TRANS/WP.29/GRE/2002/4/Rev.1
17 July 2002

World Forum for Harmonization of Vehicle Regulations (WP.29)

PROPOSAL FOR DRAFT AMENDMENTS (SUPPLEMENT 2 TO THE 02 SERIES)
TO REGULATION No. 10

Transmitted by the Expert from Japan

Fig.1 Distribution of correlation between initial step method and 10m/3m method with expanded FM band (vehicles with a European-specification antenna)

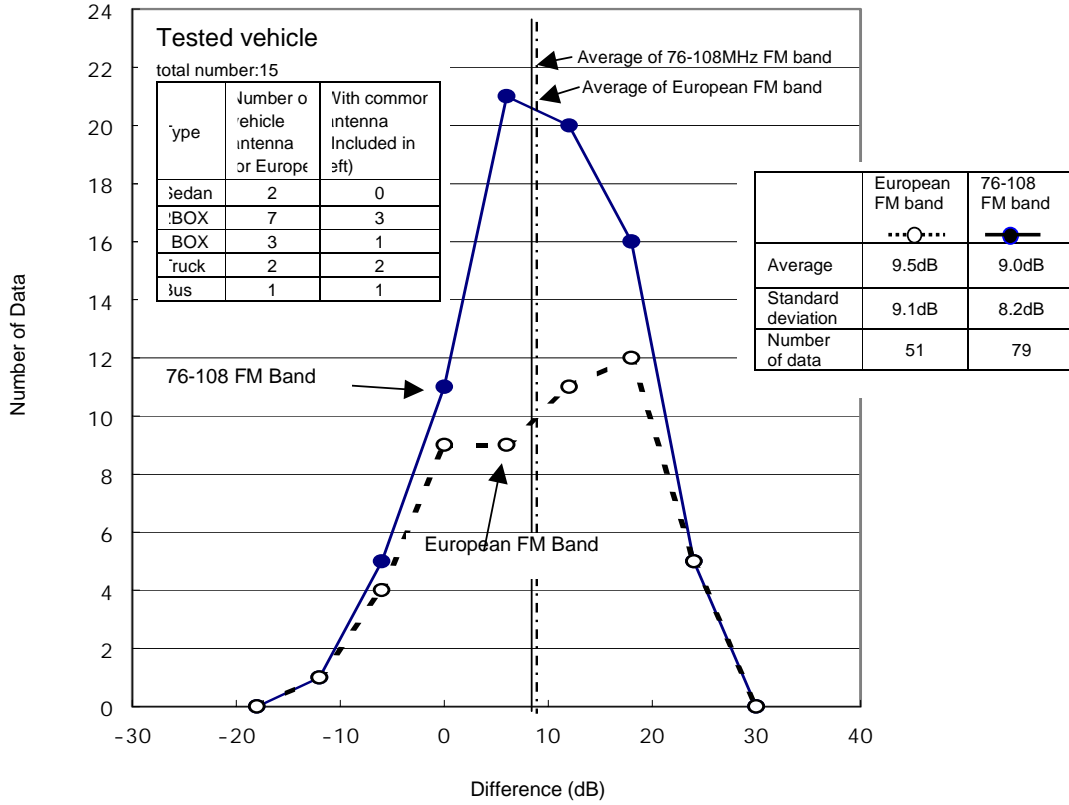
An experiment was conducted on 15 test vehicles equipped with a European-specification antenna. Figure 1 shows the level of correlation between the initial step test results obtained with the current FM band and those obtained with the amended (76-108 MHz) band from the vehicles. The correlation data were on the balance of [A] the margin of the measured value from the limit value under the 10m/3m method subtracted by [B] the margin of the measured value from the limit value under the initial step method. There was no significant difference in the data distributions, mean values and standard deviations between the two frequency bands.

4. The data in Figure 1 were obtained from vehicles equipped with a European-specification antenna over the total 76-108 MHz band (n=79) and over Europe's current FM band (n=51). The data distribution is indicated in the graph, and the mean values and standard deviations are also given.

Fig.2 Distribution of correlation between initial step method and 10m/3m method with expanded FM band (vehicles with a Japanese-specification antenna)

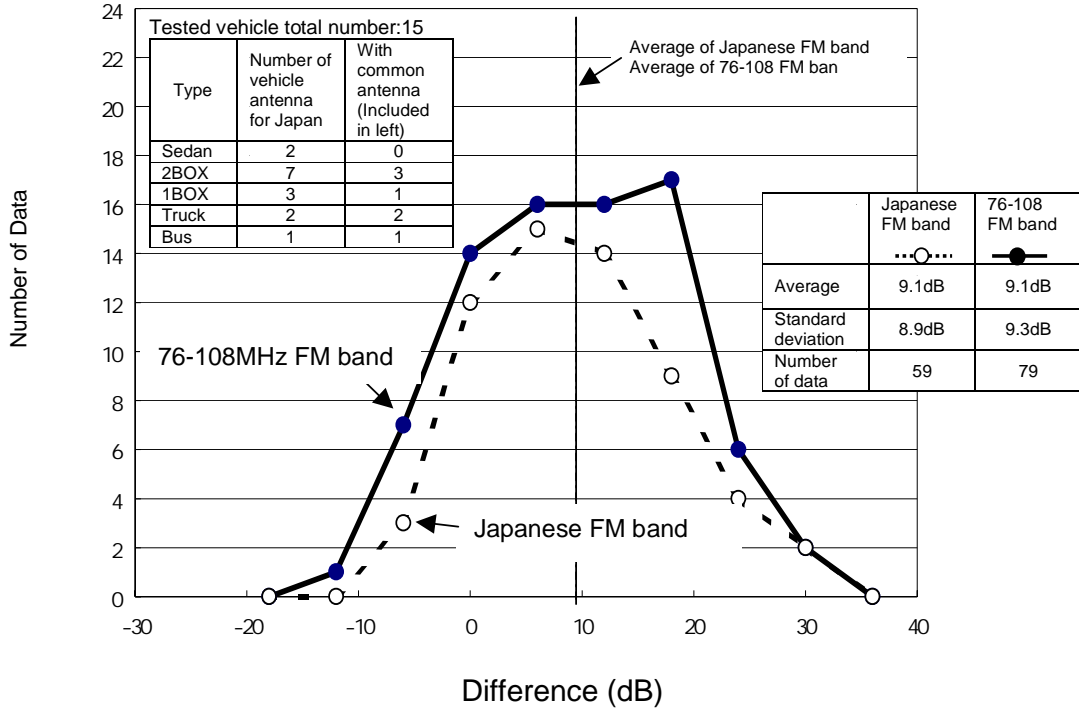
A similar experiment was carried out on the same 15 test vehicles but equipped with a Japanese-specification antenna. Figure 2 shows the level of correlation between the initial step test results obtained with the Japanese FM band and those obtained with the amended (76-108 MHz) band from the vehicles. Similarly, there was no significant difference in the data distributions, mean values and standard deviations over the two test frequency bands.

The data in Figure 2 were obtained from the same vehicles but equipped with a Japanese-specification antenna over the total 76-108 MHz band (n=79) and over Japan's current FM band (n=59). The data distribution is indicated in the graph, and the mean values and standard deviations are also given.

Fig.3 Distribution of correlation between initial step method and 10m/3m method with the FM band matching the antenna specification

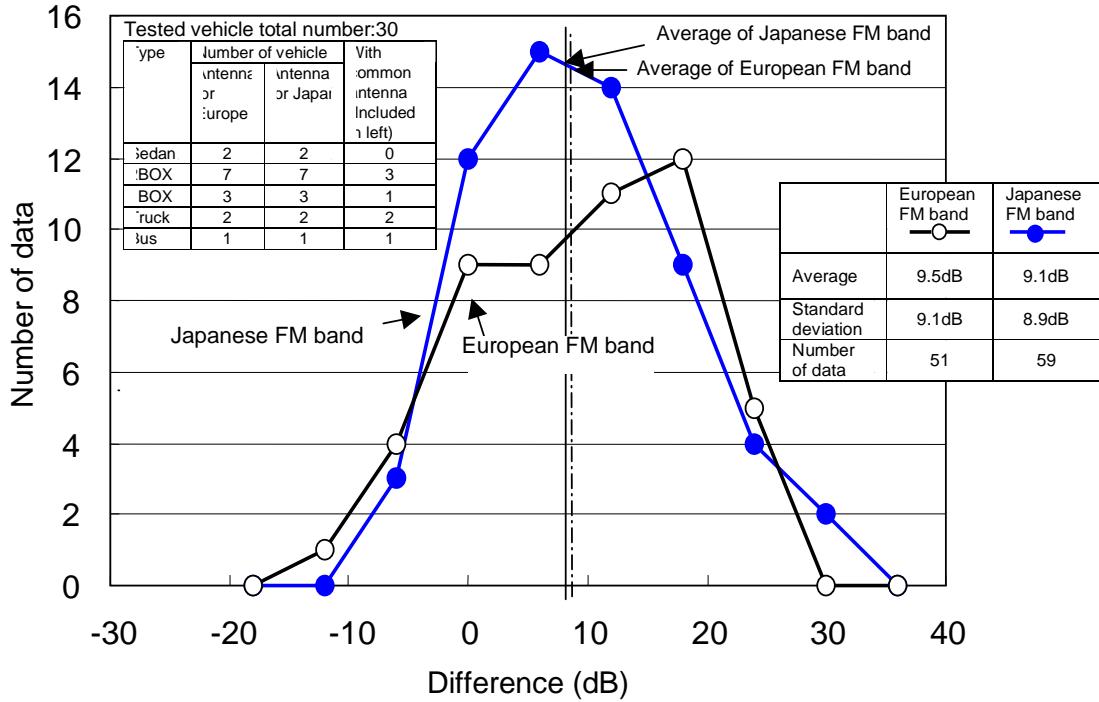
Moreover, Japan previously confirmed that identical data could be obtained between the use of Japanese-specification antennas over the 76-90 MHz band and the use of European-specification antennas over the 88-90 MHz band. This was reported to the 48th GRE as formal document TRANS/WP.29/GRE/2002/4 (Fig. 3).

Figure 3 compares the measurement data over the Japanese FM band when a Japanese-specification antenna was installed, and the measurement data over the European FM band when a European-specification antenna was mounted.
